Proposed Draft Conditions

Plan A RM230535

DIGITAL BILLBOARD - URBAN DESIGN AND VISUAL IMPACT ASSESSMENT GRAPHIC ATTACHMENT
PROPOSAL - BILLBOARD ELEVATED PERSPECTIVE
 2023.025 BECON MEDIA - 332 QUINN STREET

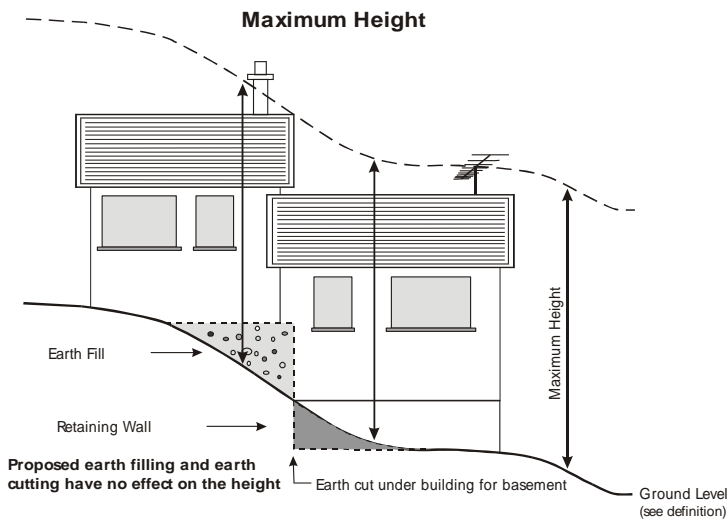
Commented [VW1]: I would like to have this condition included to reflect TDC's standard practice. However, note that condition 1 will require construction in accordance with the approved plan this just spells out that detail in terms of parapet height.

Commented [AC2R1]: I'd prefer not to include this. What if the building owner wants to put on a second storey behind the parapet. It's a permitted activity that may create noncompliance with the consent conditions. I prefer this condition is not included and do not consider it necessary for effects management, as the parapet is described in condition 1 and required to be built by condition 3.
